**Willis V. Carrier Recreation Center**  
**Town of DeWitt**  
Project No. TOD PH3

## **Addendum No. 2**

Willis V. Carrier Recreation Center - Phase 3

**4** **WARNING TRACK**  
AD2 SECTION • NOT TO SCALE 3230-407  
© APPEL OSBORNE LANDSCAPE ARCHITECTURE

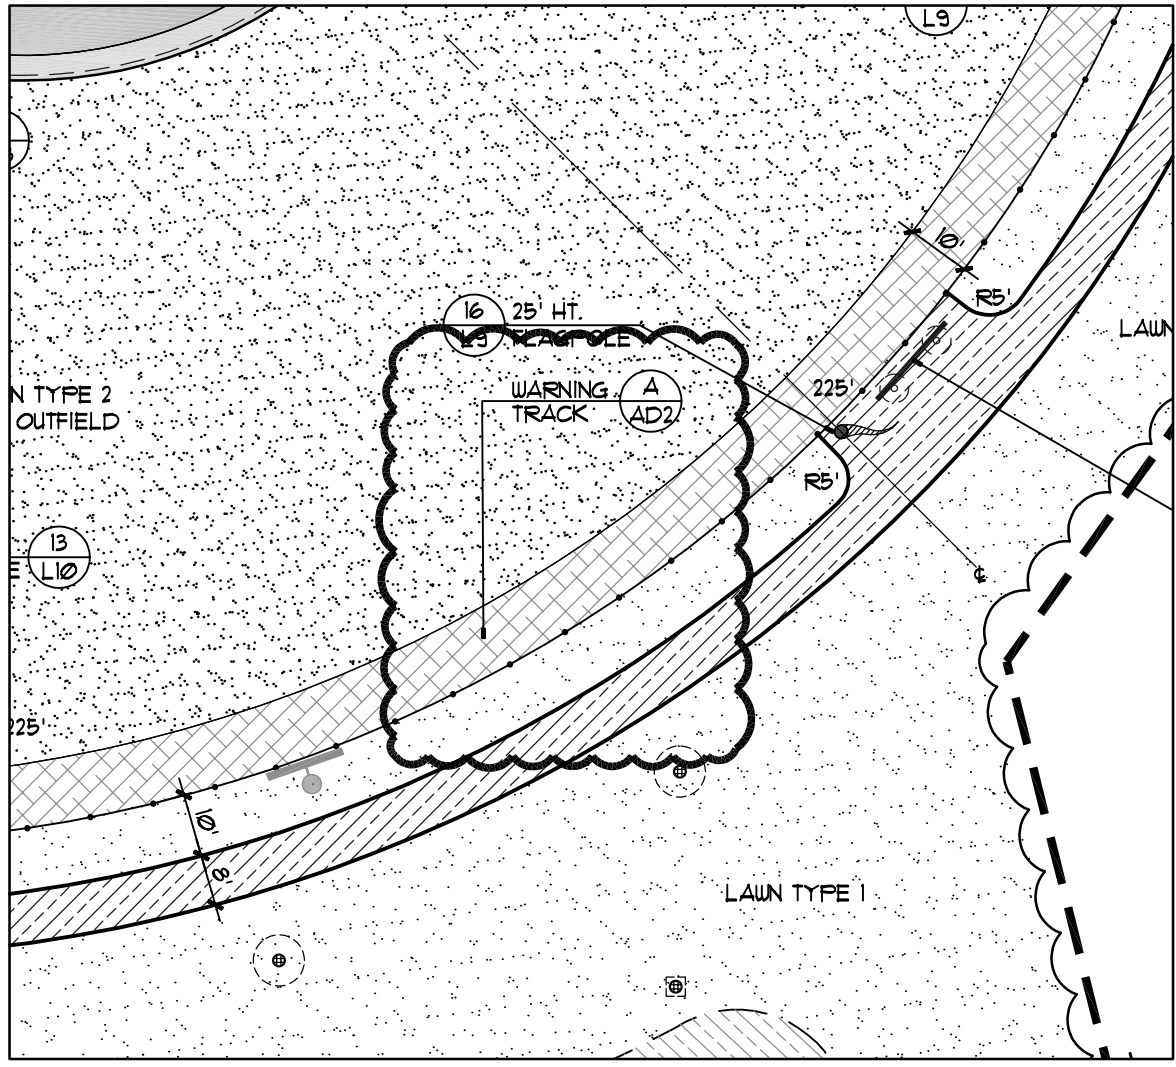
Answer: See drawing AD2-L3, and also see bid specification section 323003 for warning track material
16. RFI: Is there an item for stone mulch?  
Answer: Provide No.3 round river cobbles, installed depth of 6".

**BACKSTOP WITH CANOPY - 24' HEIGHT**  
SECTION • NOT TO SCALE M275-004B

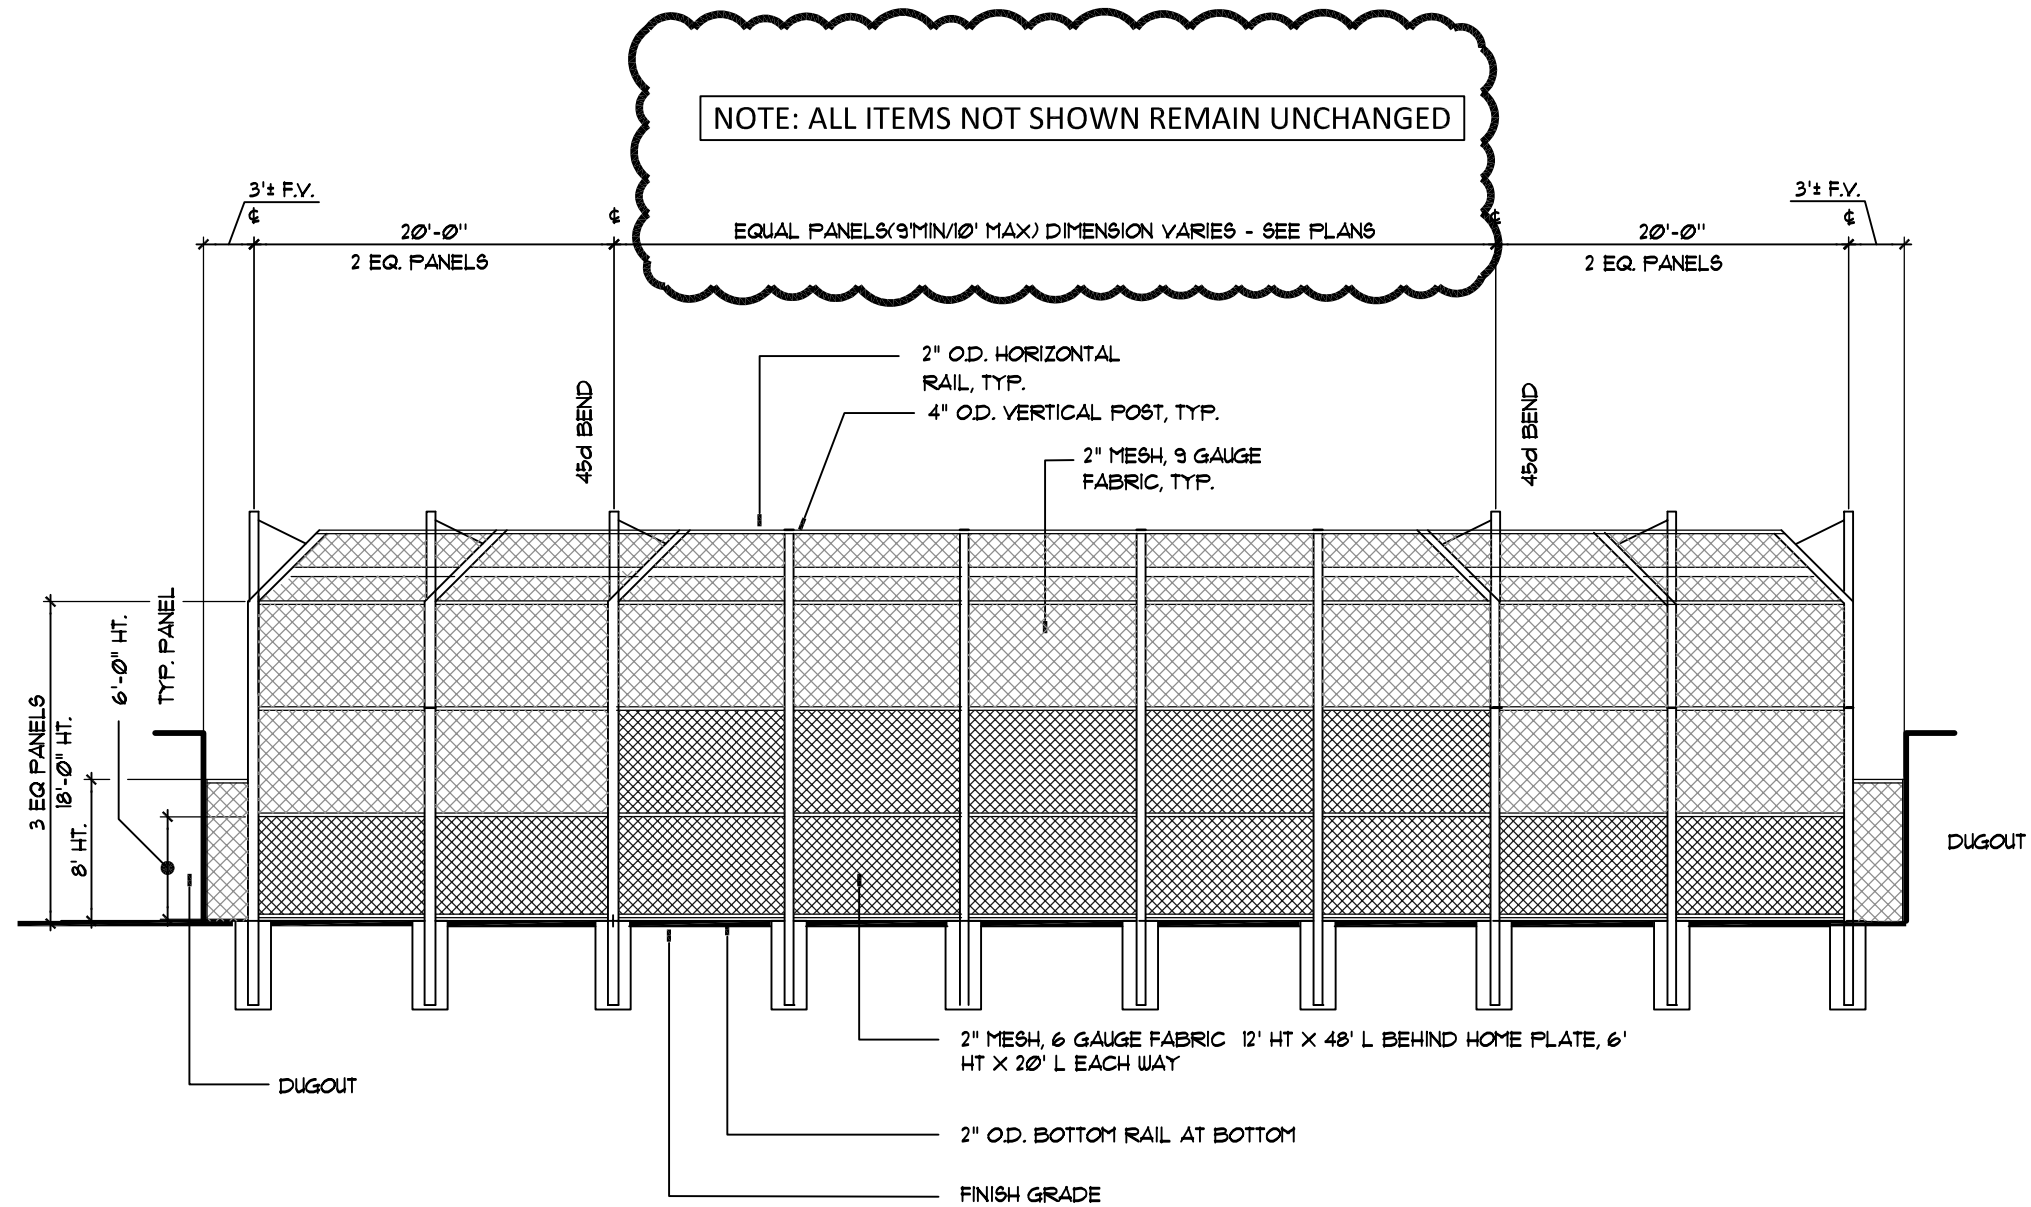
18. RFI: Sheet E.7- Keynote 1 Backbox typical of 4, is this pole mounted? Who provides and what type of pole? It does not show circuitry.  
Answer: Camera back boxes will be mounted on the backstop fencing. Refer to Addendum drawing AD2-E1 for additional information.

**AD2-P1**

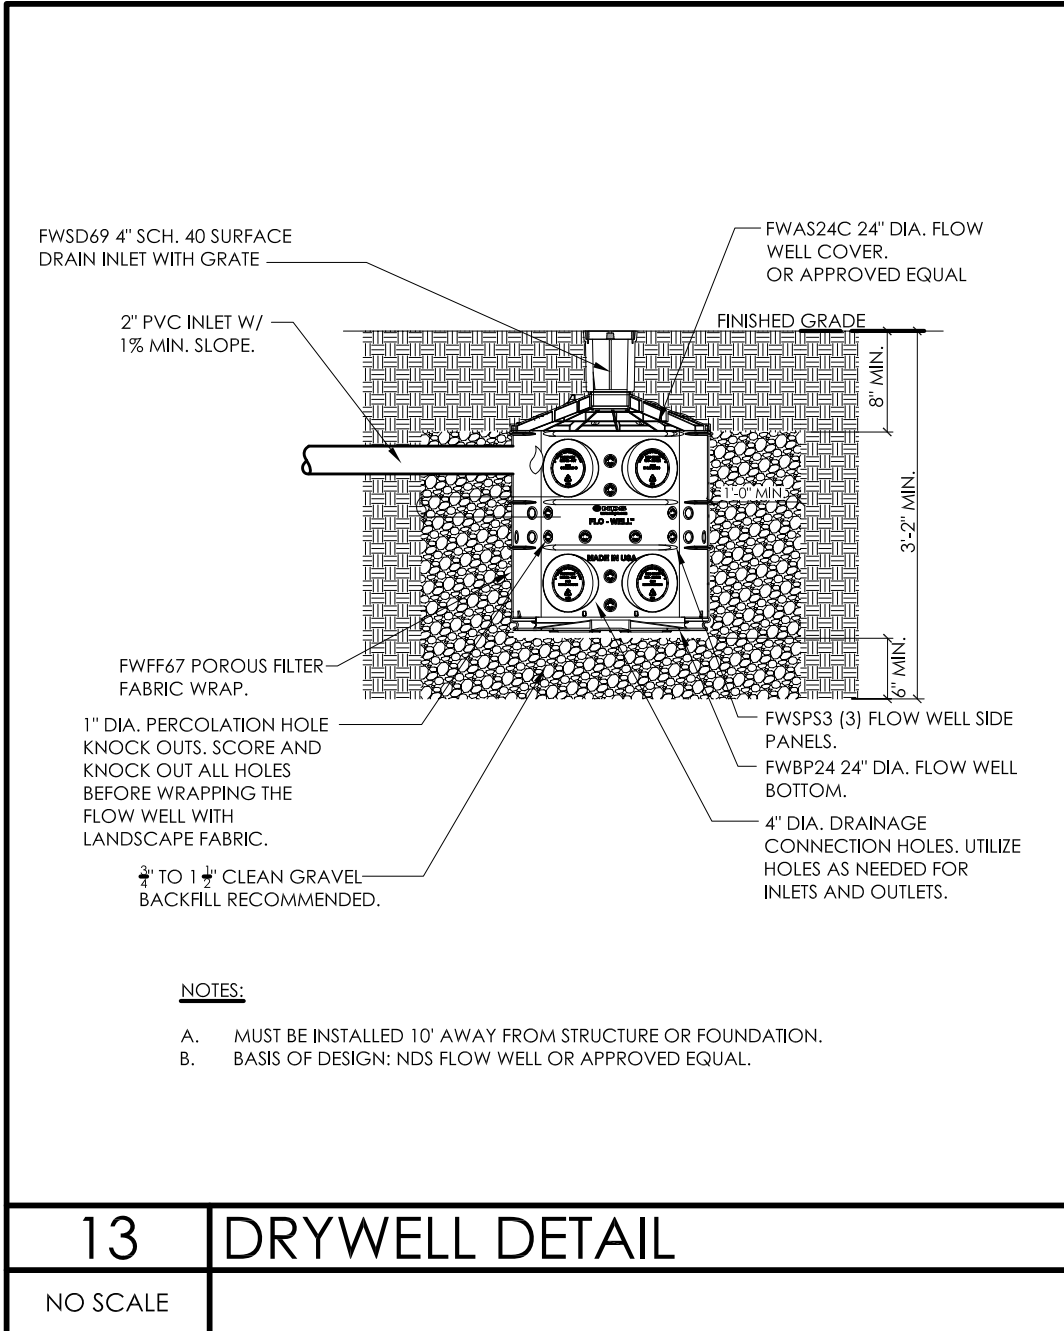
6. RFI: Who provides the Drywell detail on Drawing P6?  
Answer: Drywell is provided by the Plumbing contractor. Refer to Addendum #2 drawing AD2-P1 for Drywell detail.

- e. On sheet P2:
  - 1. **REVISE** Pavillion Sanitary and Waste piping configuration to what is indicated on AD2-P3 and AD2-P4.
- f. On sheet P6:
  - 1. **ADD** Drywell Detail AD2-P1. Drywell is to be furnished and installed by Plumbing Contractor.

4	PIPE TRENCH DETAIL - EXTERIOR SANITARY
NO SCALE	DRAINAGE PIPING

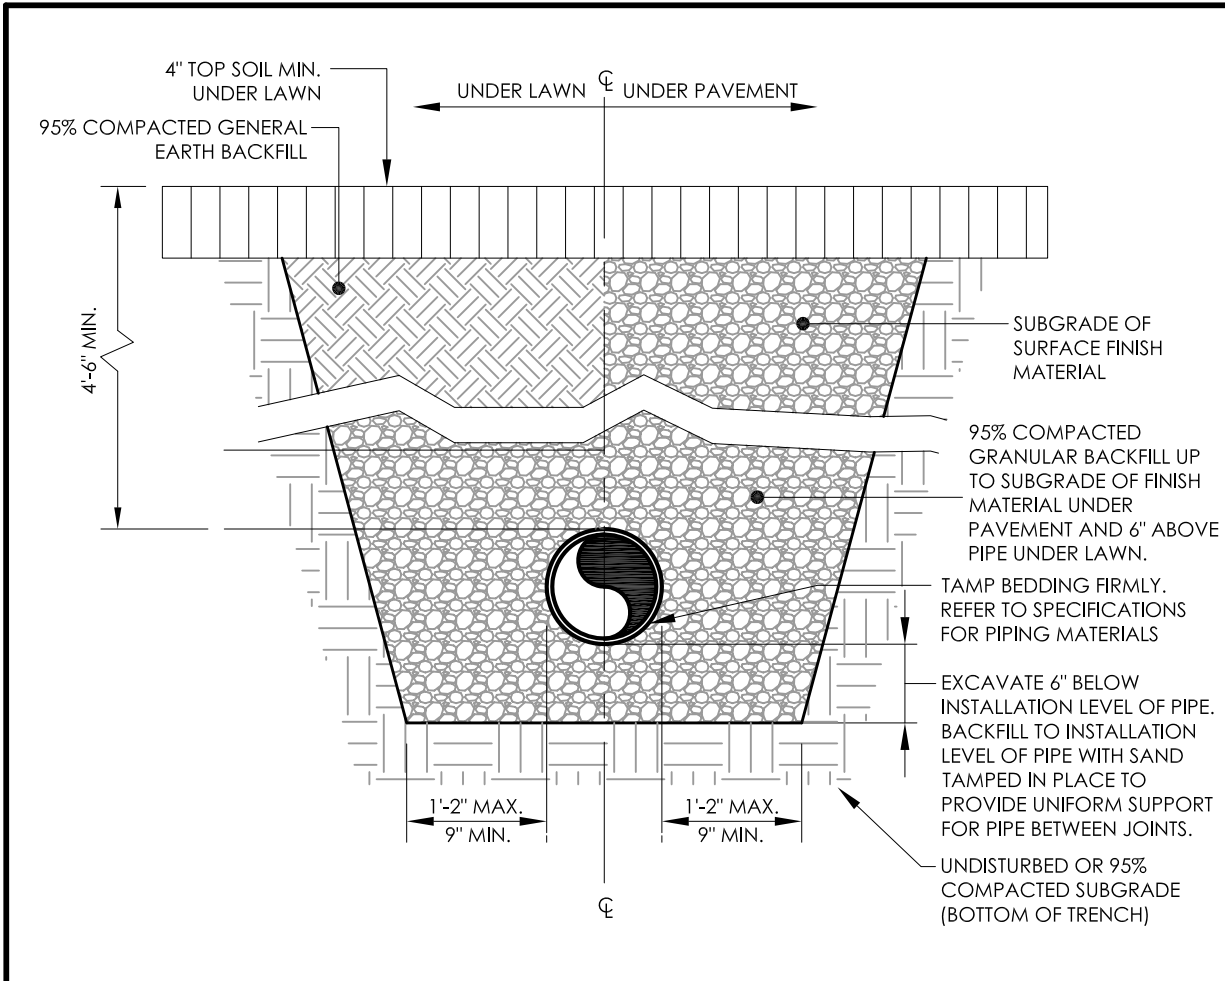
- g. On sheet P7:
  - 1. **REVISE** Exterior Pipe Trench Detail 4 to what is indicated on AD2-P6.
- h. On sheet P7:
  - 1. **DETAIL 15** – CHANGE Domestic Water Service Size from 4” to 2”.
